California High-Speed Train Project

Request for Proposal for Design-Build Services

RFP No.: HSR 11-16
Design Variance Report

06/29/2012 ADDENDUM 3 - RFP HSR 11-16

Appendix A – Option Layouts

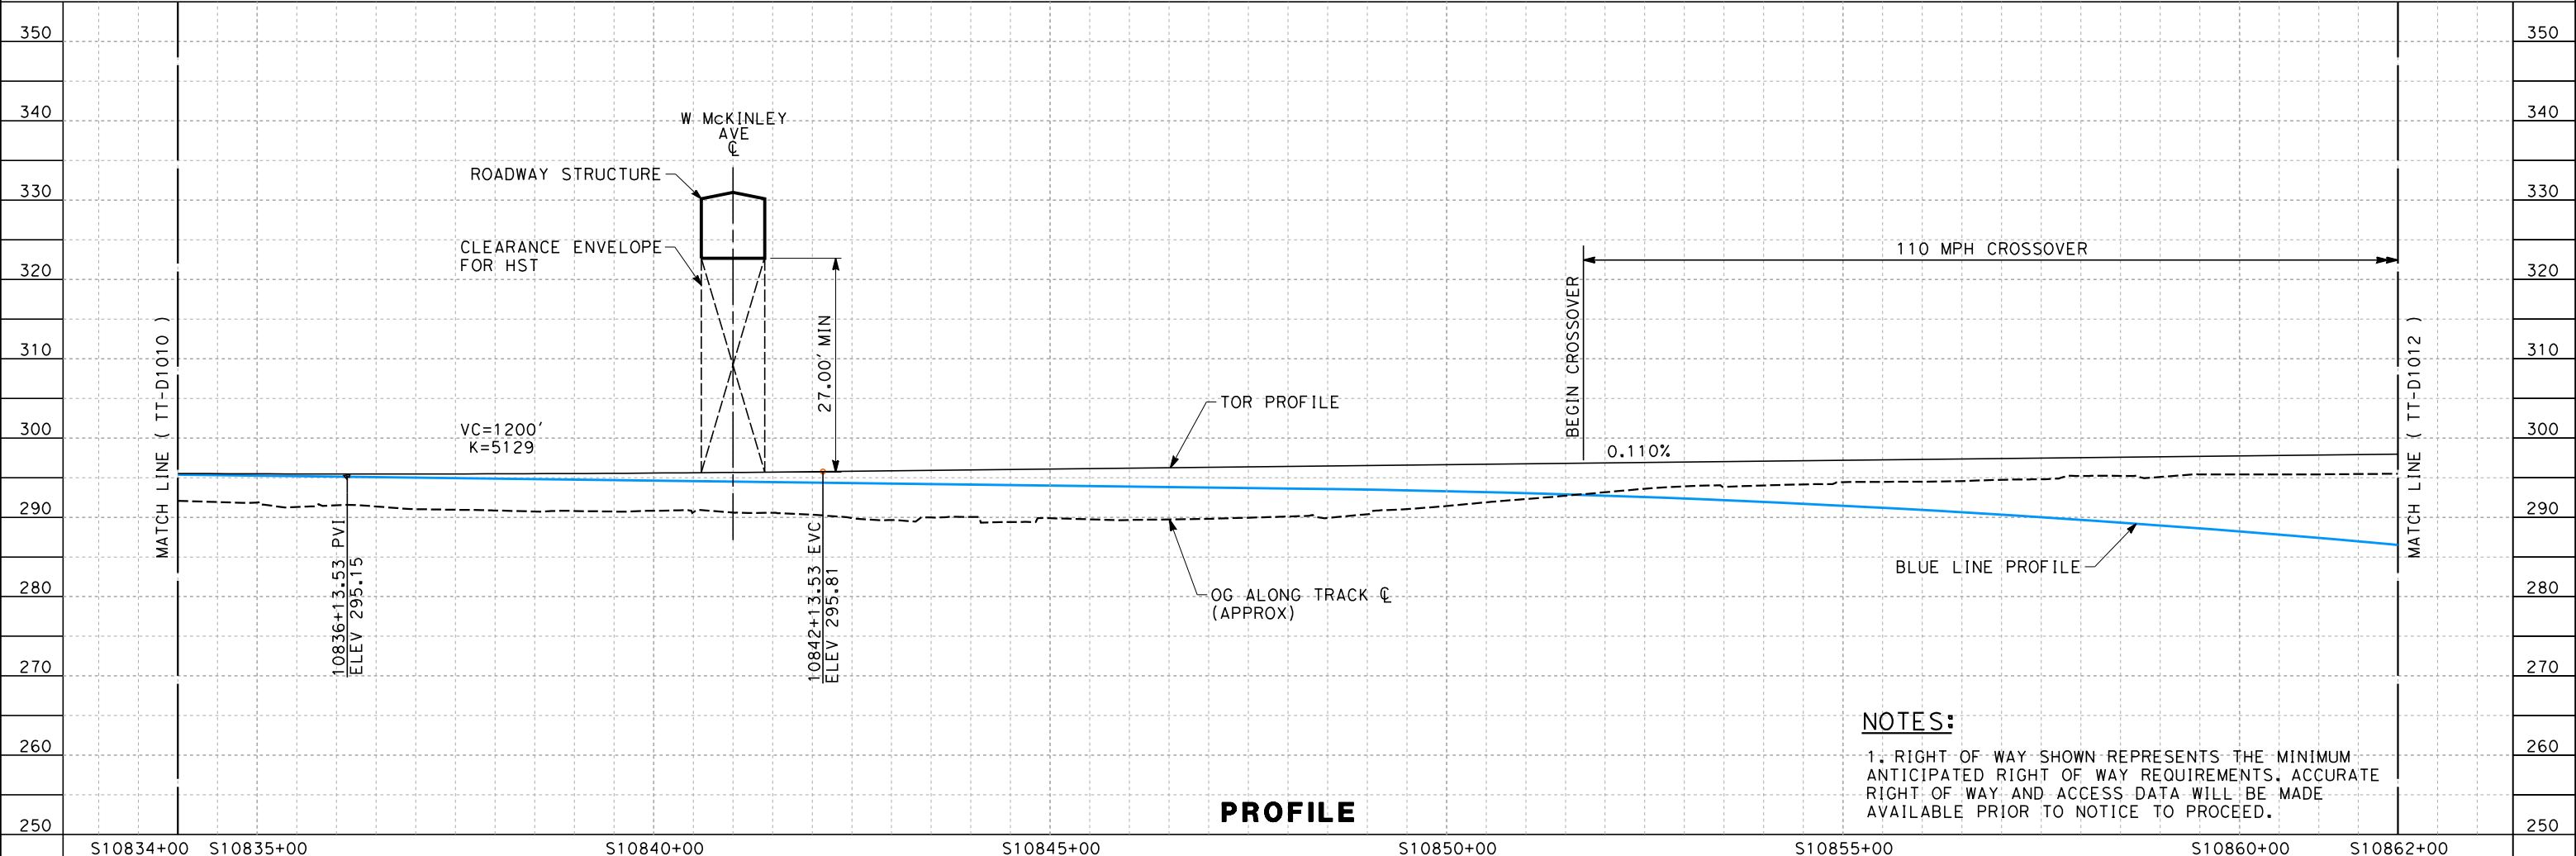
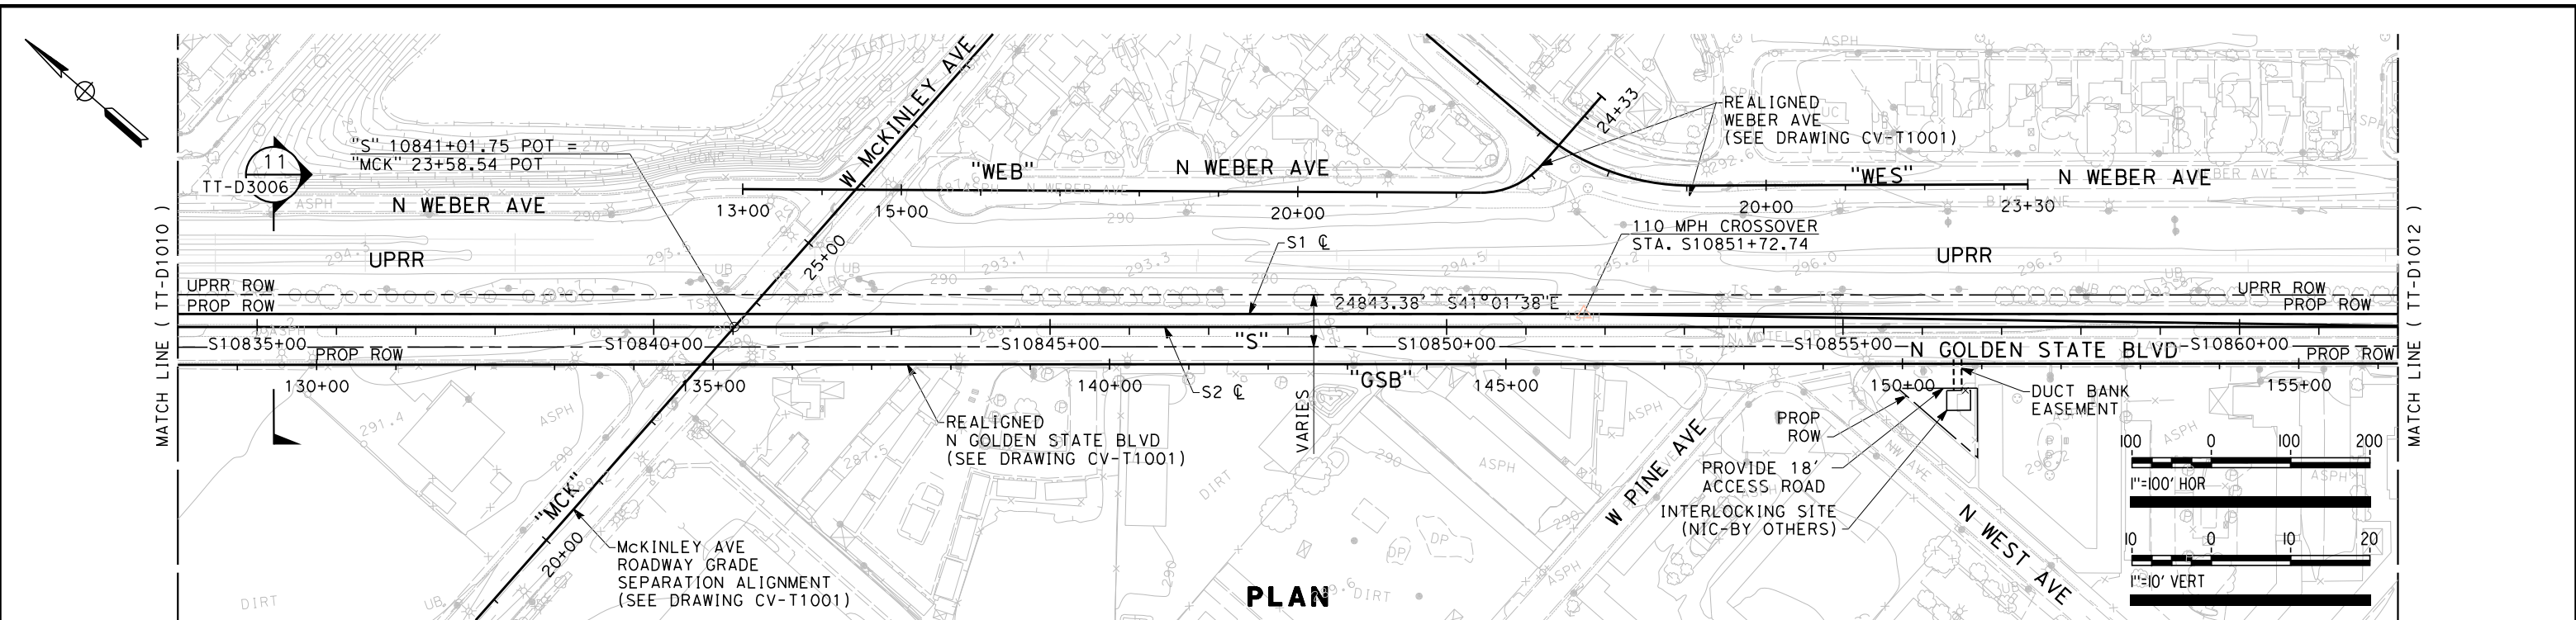
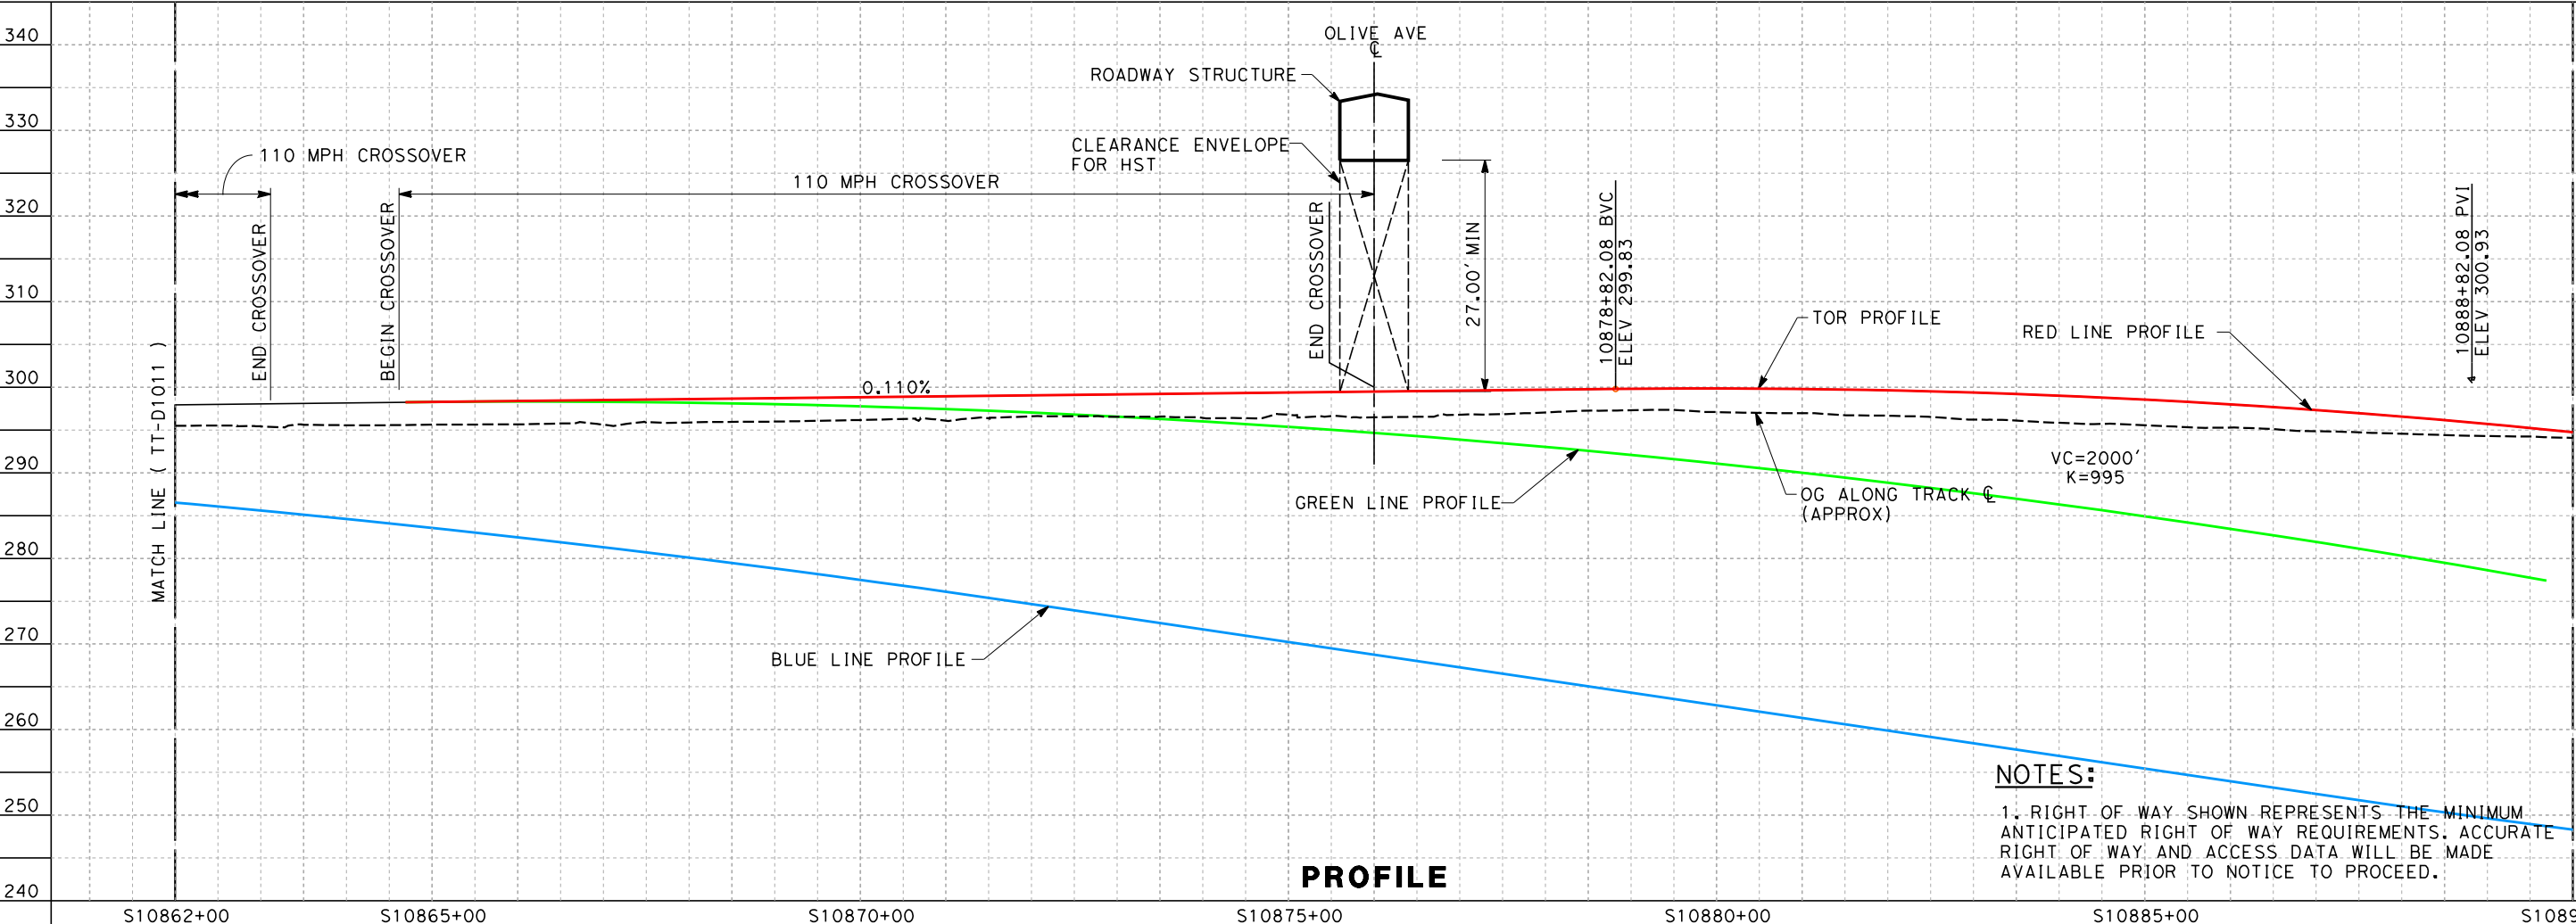
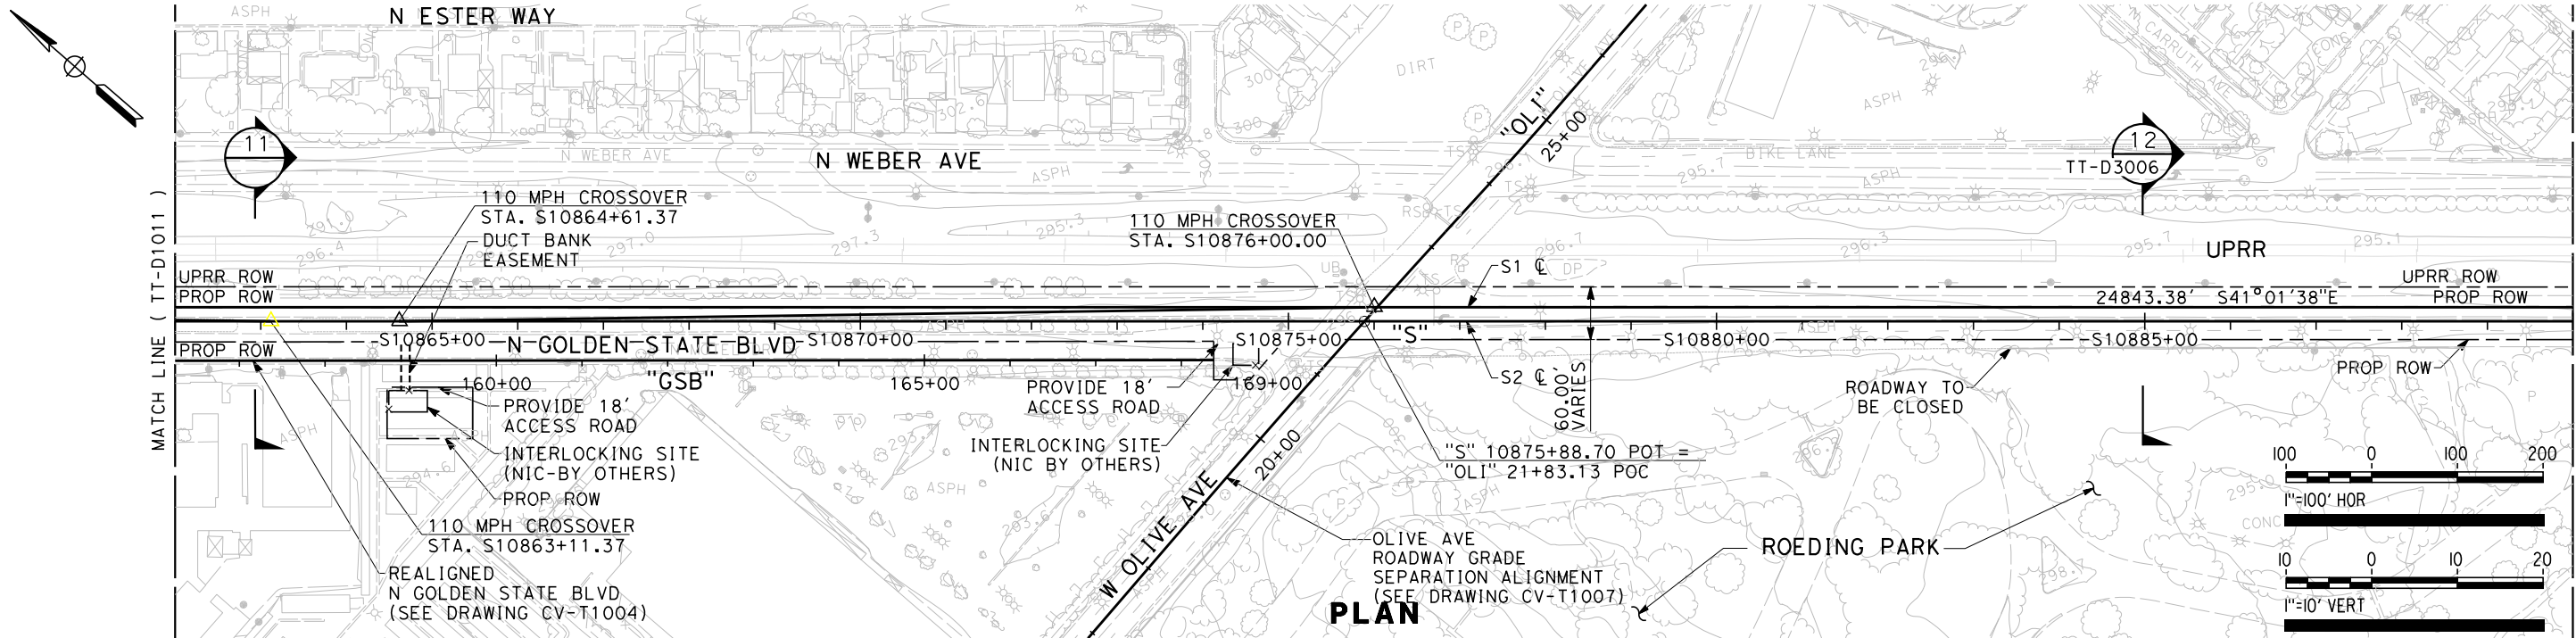
JUSTIFICATION FOR VARIANCE	The proposed design (red line — within exceptional alignment criteria at 220mph) minimizes the extents of trench and the distance between the

<p>proposed station and crossovers.</p> <p>The trench is 7,940ft long with a maximum depth of 42ft. The vertical curves are 2,000ft and 3,300ft long, respectively, and are approximately midrange between minimum criteria and exceptional criteria. The connecting straight meets minimum criteria.</p> <p>The distance between the station and the crossovers requires a design variance and will be made worse by the minimum (green line) and desirable (blue line) vertical alignments.</p> <p>Options for a 220mph desirable vertical alignment and a 220mph minimum vertical are shown in Appendix A. Significant differences to the proposed scheme are detailed below.</p> <p>Impacts of the 220mph desirable trench (blue line):</p> <p>A 220mph alignment that meets the desirable criteria would also allow for 250mph at minimum criteria.</p> <p>The total length of trench is 11,680ft with a maximum depth of 54ft. The crossovers are moved a further 3,060ft away from the station. This significantly worsens the crossover to station distance design variance.</p> <p>Impacts of the 220mph minimum trench (green line):</p> <p>The total length of trench is 9,700ft with a maximum depth of 48ft. The crossovers are moved a further 1,410ft away from the station. This worsens the crossover to station distance design variance.</p> <p>The preceding vertical curve at STA 10836+14 is moved north 1,400ft to create sufficient length for the crossovers. This has no significant impact.</p>

PROPOSED ALTERNATIVE DESIGN REQUIREMENT	<p>The proposed 220mph exceptional (red line) alignment represents a balance between achieving the minimum criteria and minimizing crossover to station distance and trench length.</p>

Summary of options:		
	Option	Speed (mph)	Length (ft)
	Blue	220	VC1=2400
			STR=1475
			VC2=5300
	Green	220	VC1= 2500
			STR=858
			VC2=4350
	Red	220	VC1= 2000
			STR=993
			VC2=3300
Overlap of vertical curve and horizontal spiral:			
<p>The location of the vertical curve is constrained by the requirement to pass under the existing structure at SR-99, the proposed Dry Creek culvert and the SJVR. The overlap between the elements is approximately 3,440ft for the red line and 4,000ft for the blue and green lines. Extending the straight approaching the station back through the horizontal curves and spirals would create a trench in excess of 100ft deep. This is shown by an orange dashed line in the appended drawings. This is considered unreasonable.</p>
